Wateridge Lifestyles - Phase 1 Retirement Home

Block 21 - 200 Codd's Road, Ottawa ON K1K 5C6

Prepared For: City of Ottawa - Urban Design Review Panel

City of Ottawa File No. PC2025-0281

Built-Form Transition – 200 Codd's Road & 375 Codd's Road – West Elevations

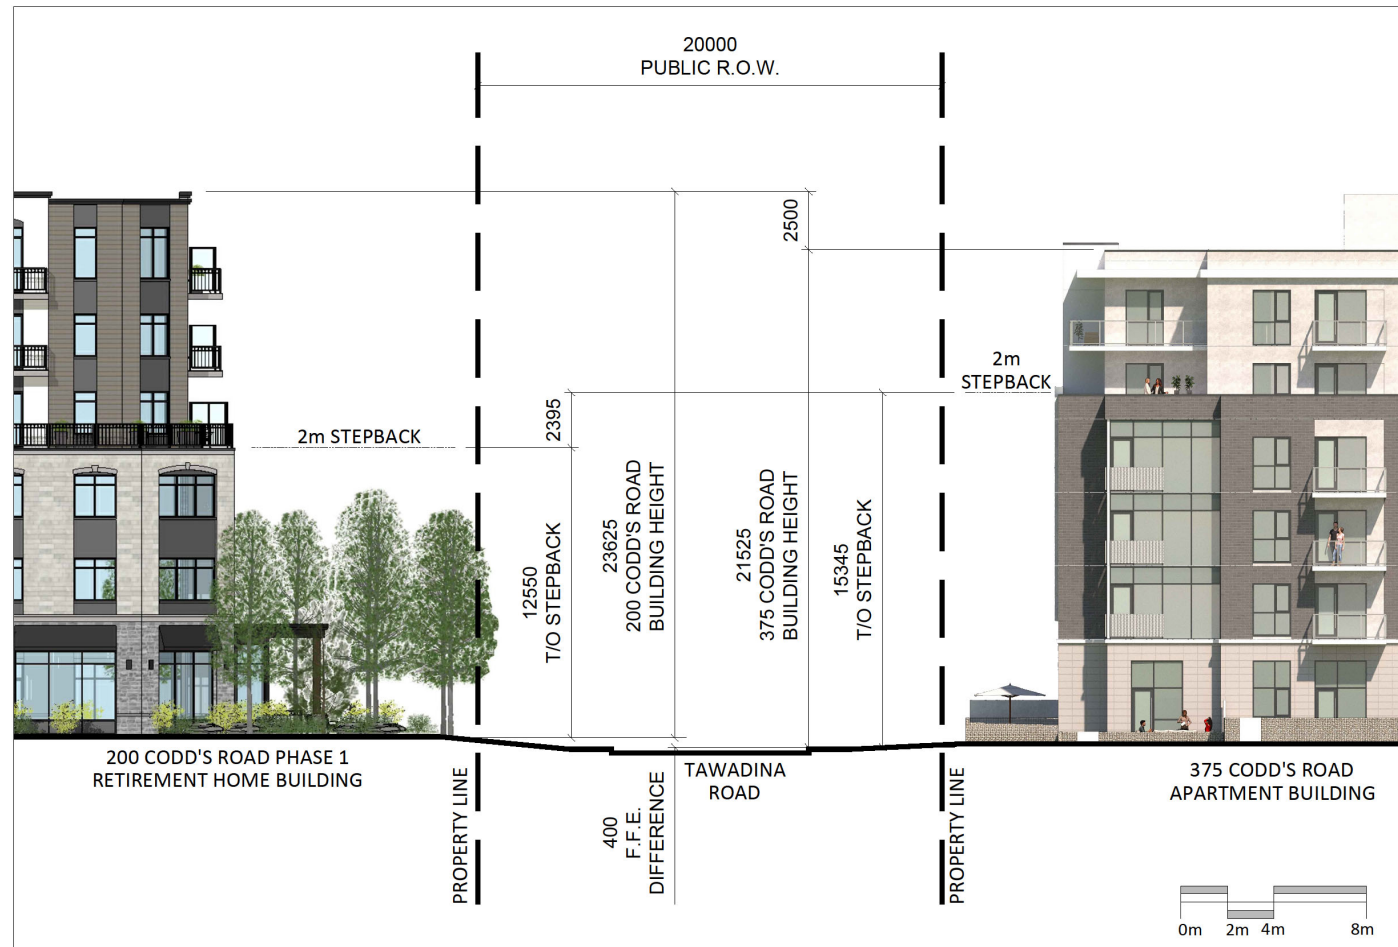
Provide a base/middle/top approach to building design. Please rationalize the proposed height of the building base proposed based on datum lines taken from surrounding development. A building step back should be provided above the building base to provide a human scaled development and to provide transition to surrounding development.

Response – Please refer to the 3D renderings included in this Urban Design Brief, Section 4.4 – Built Form Transition, and to the solid-coloured hatches shown for the three buildings on the Master Site Plan (Drawing 1/A1.1) which designates the low, middle and high tiers of the buildings. As required by the site-specific zoning [GM31 H(30)], the building must incorporate a 2m step back on the front and corner side yards above the fourth storey. This 2m step back has been provided for all three buildings and on all building faces fronting the public R.O.W. to conform with zoning and to provide a human scale development at the street level.

Please note that the difference in building height between the two buildings is 2.1m when the lower F.F.E. of the 375 Codd's Road building is accounted for. This difference in height is primarily on account of the lower three floors levels of the Phase 1 retirement home building which require an increased floor to floor height to satisfy the programmatic elements of the large open gathering spaces and commercial kitchen on the ground floor level, and the general dining areas on all three floor levels. As an example, the ground floor level of 200 Codd's Road is 5.2m while the ground floor level of 375 Codd's Road is 4.5m.

A1.1 - Master Plan, prepared by T Bonhomme Architect, Revision No. 1, dated January 20, 2026.

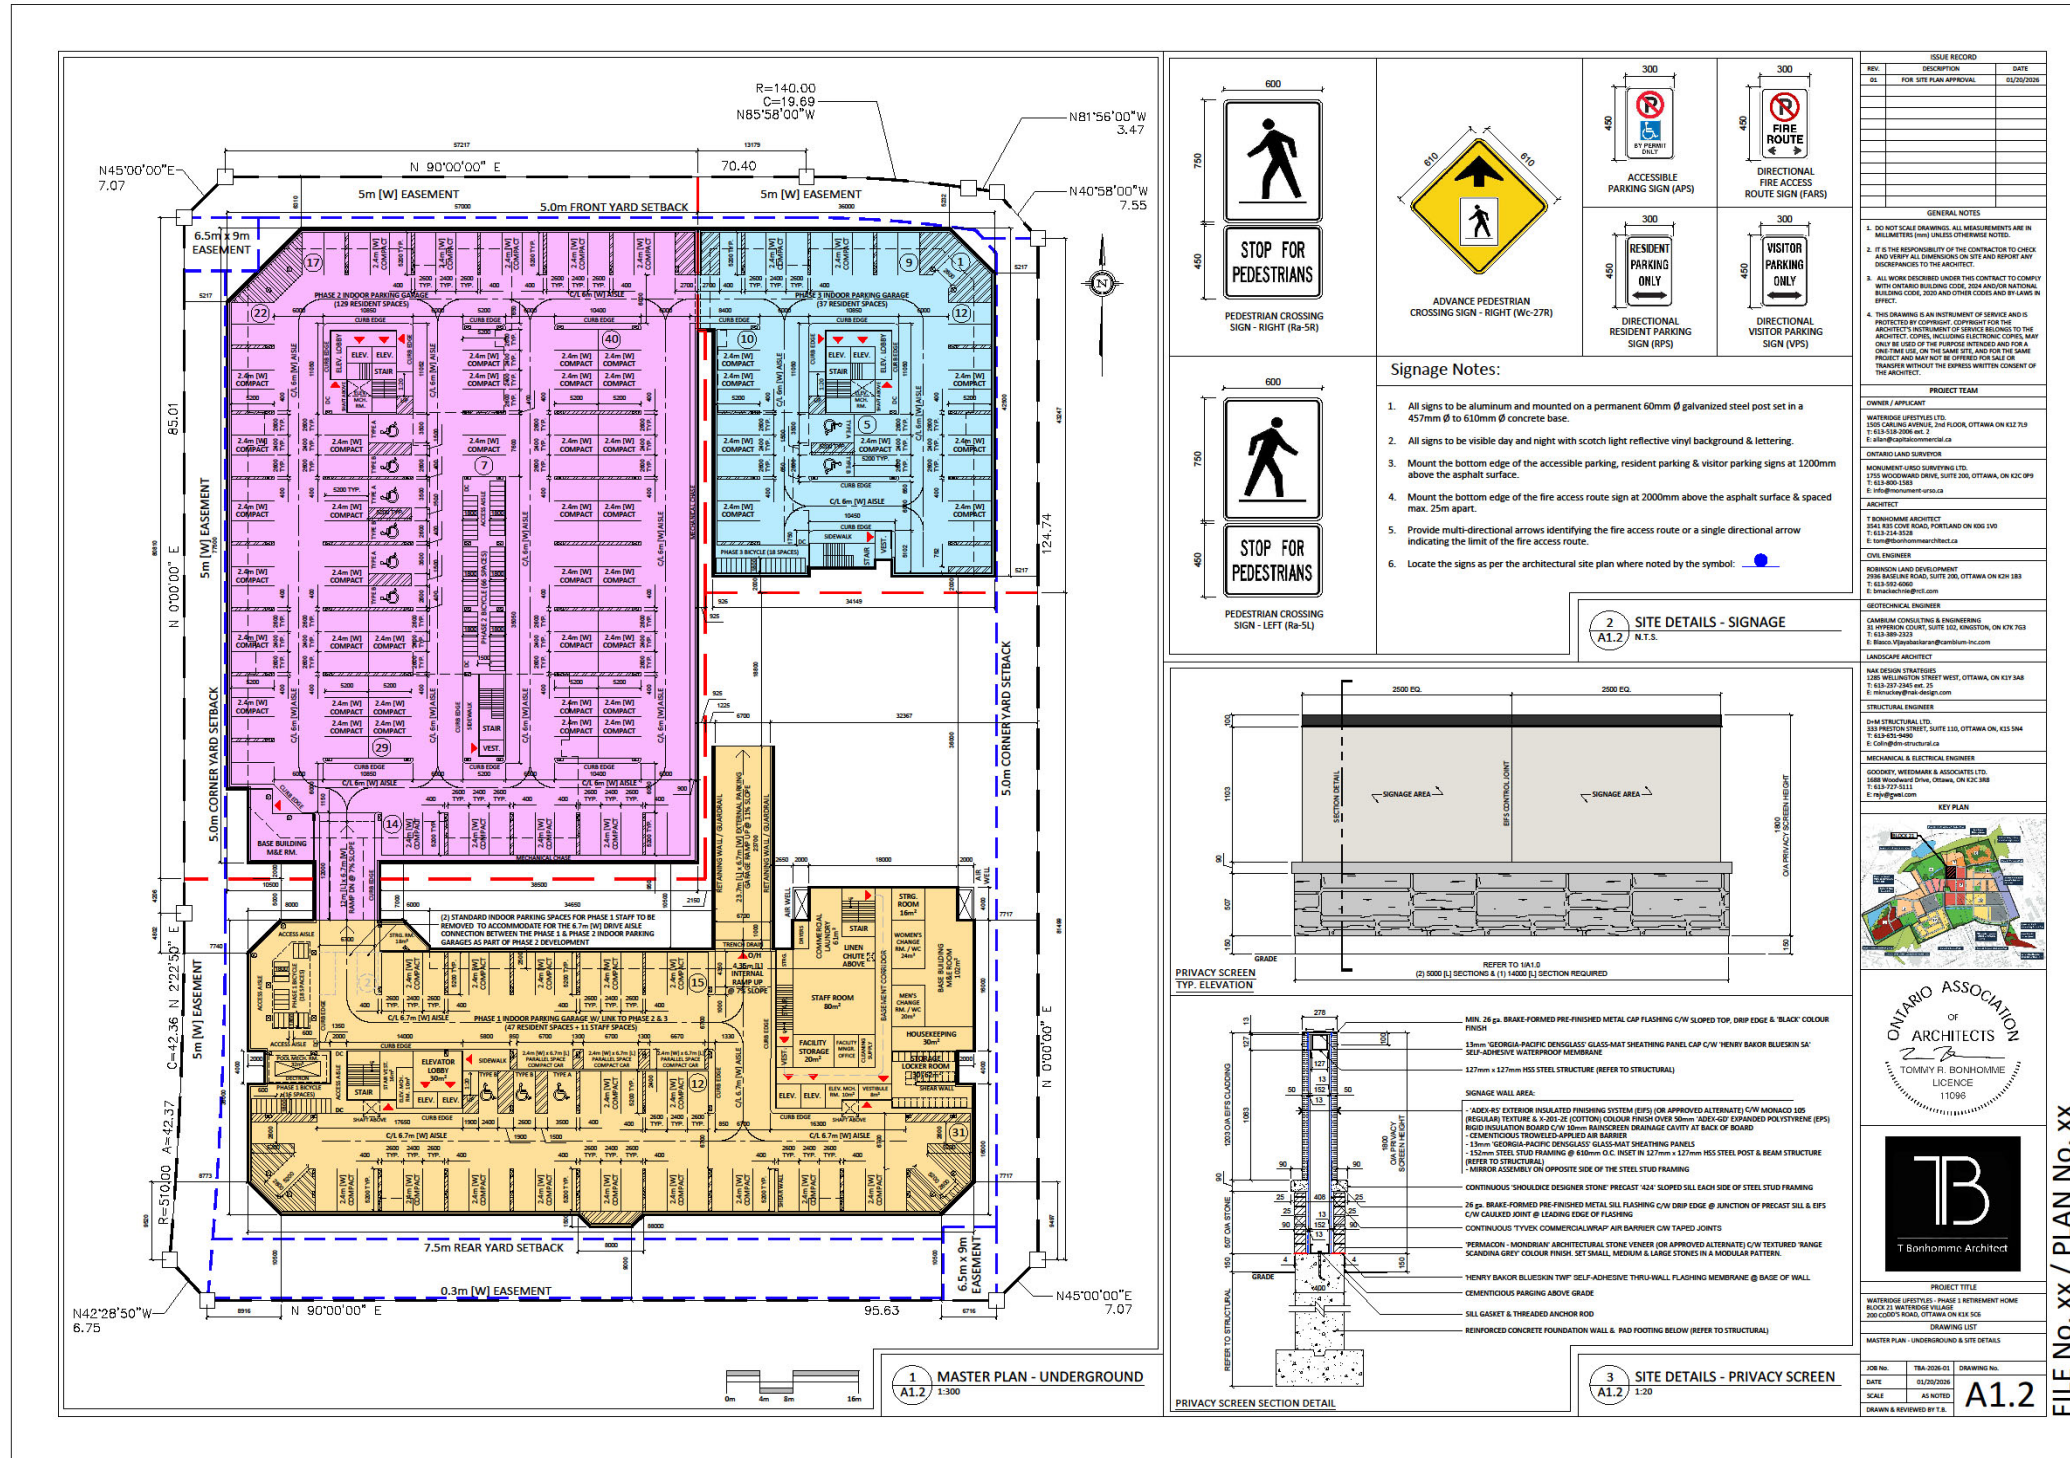
For the apartment buildings, provide ground floor terraces with landscaped edges to provide engagement with the street. Consider providing individual access to the sidewalk.

Response – Please refer to the Master Plan (Drawing 1/A1.1) which shows several individual terraces for the Phase 2 & Phase 3 buildings located along the perimeter of the site bordering West and North Codd's Road and Bareille-Snow Street. These ground floor terraces will have landscape edges and will help animate the facades by providing visual interest as well as pedestrian and resident connectivity.

A2.1 – Ground Floor Plan – Phase 1, prepared by T Bonhomme Architect, Revision No. 1, dated January 20, 2026.

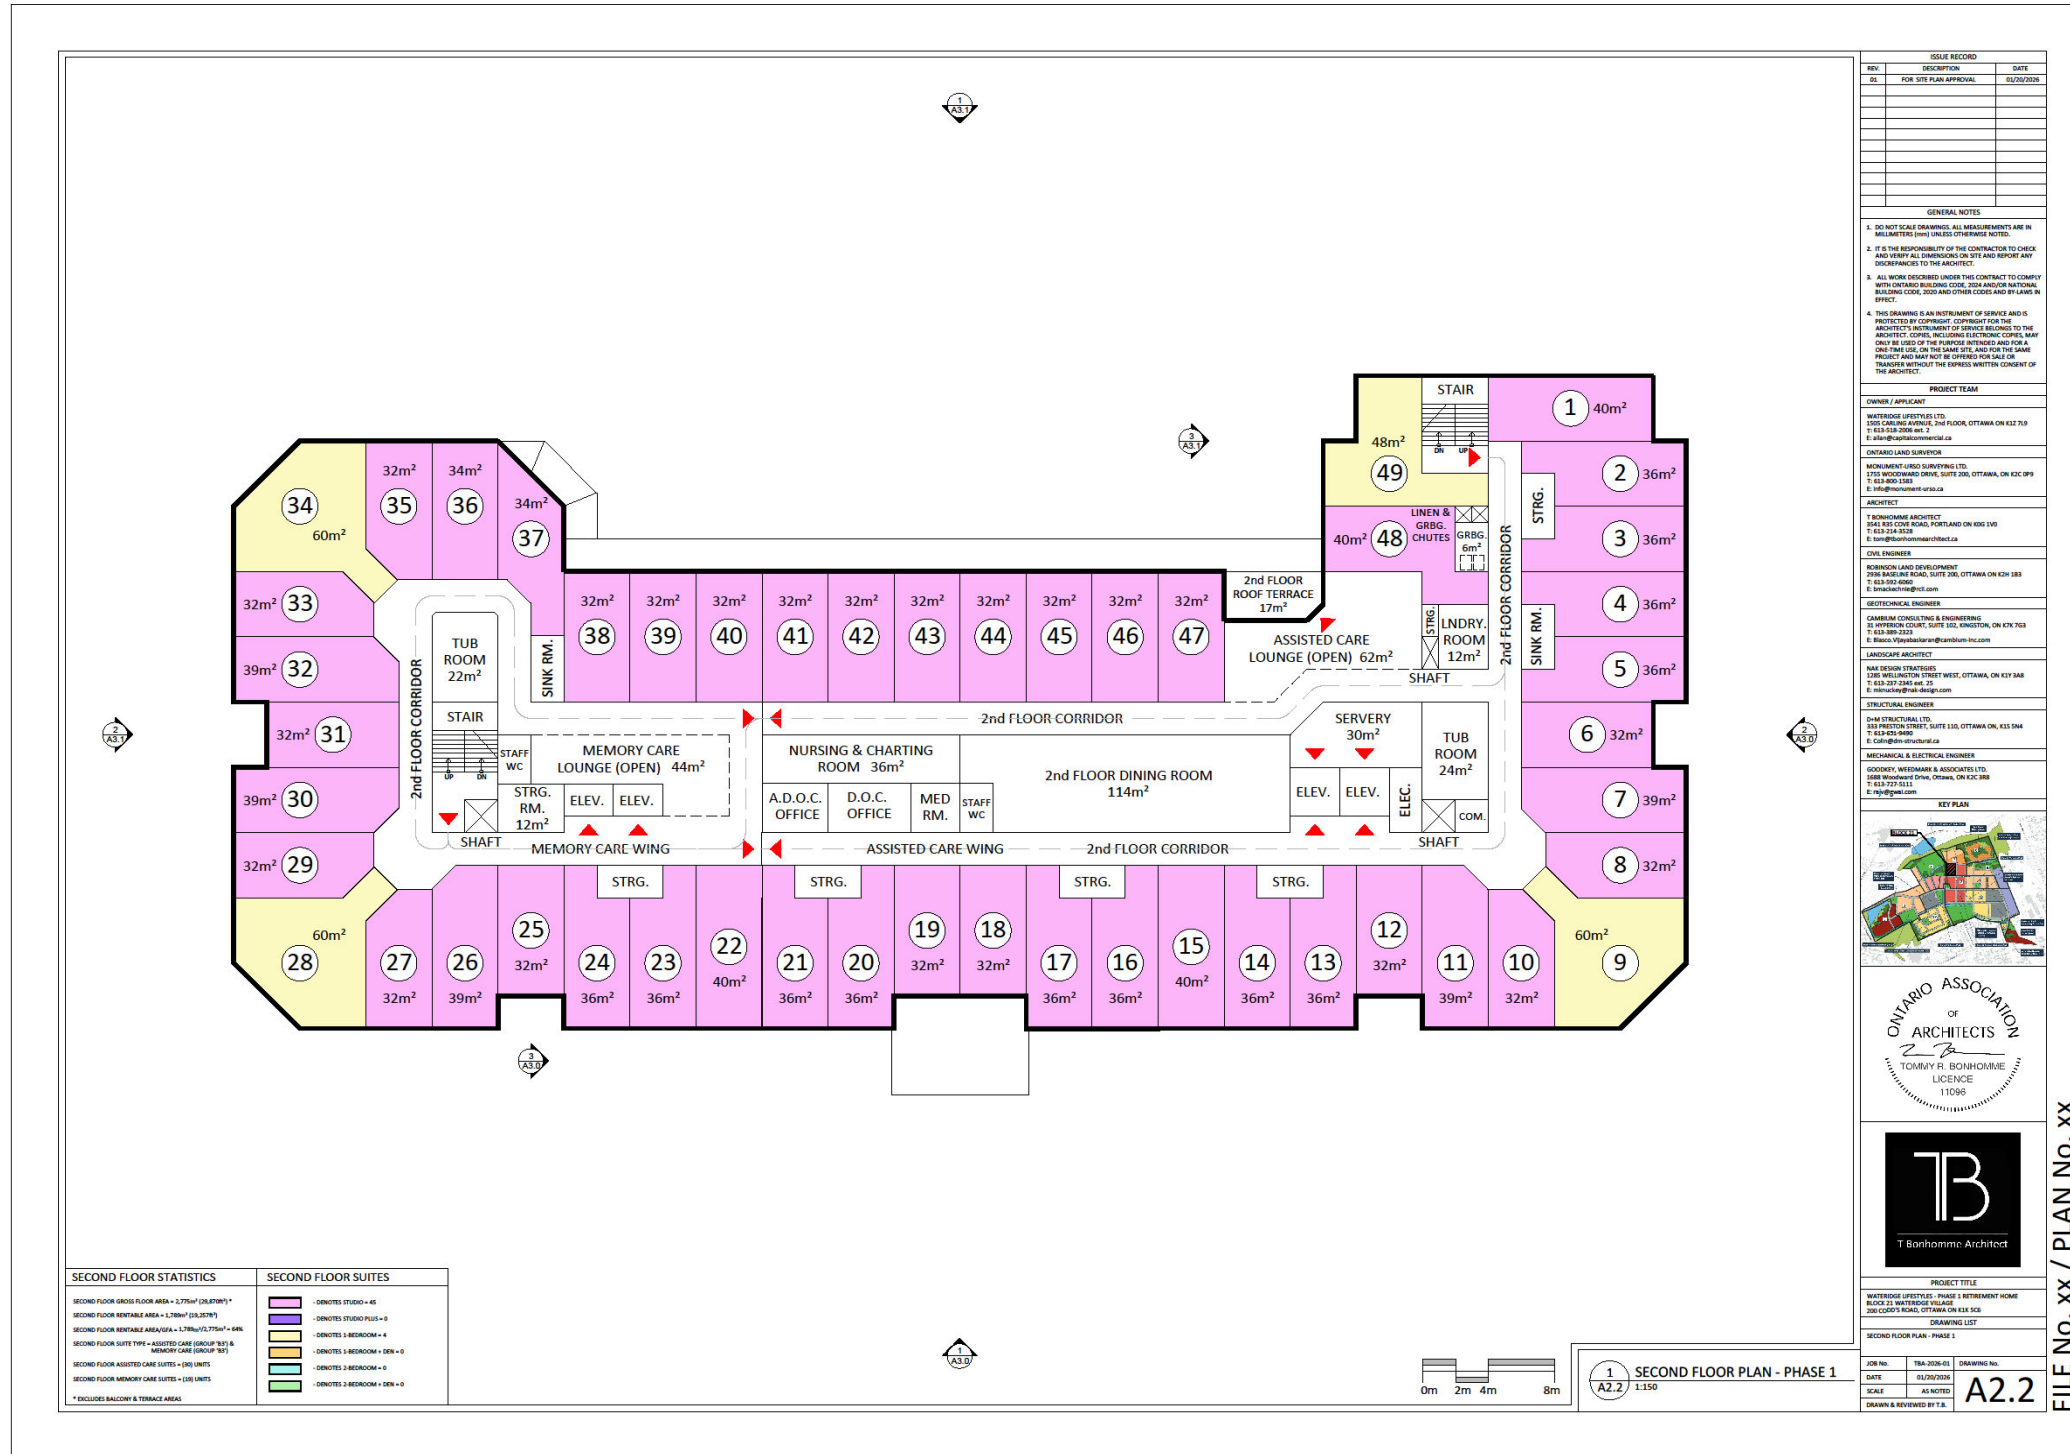
Provide active frontages along Codd's road. Including the provision of 'active uses', a high percentage of glazing and pedestrian entrances.

Response – Please refer to the 3D renderings included in this Urban Design Brief, the Ground Floor Plan (Drawing 1/A2.1) and West Elevation (Drawing 2/A3.0). As shown in the renderings and elevations, there will be large 3.658m (12ft) high aluminum windows with awnings above located along the full Codd's Road elevation for the Phase 1 retirement home, as well as along the front of the building facing Tawadina Road and the rear of the building facing the landscape and amenity areas. The high percentage of glazing provided will animate the façade through the 'active uses' contained therein and consisting of the indoor pool and exercise room along West Codd's Road, and the party room with craft kitchen, lobby and open bistro & games area along the front of the retirement home along Tawadina Road.
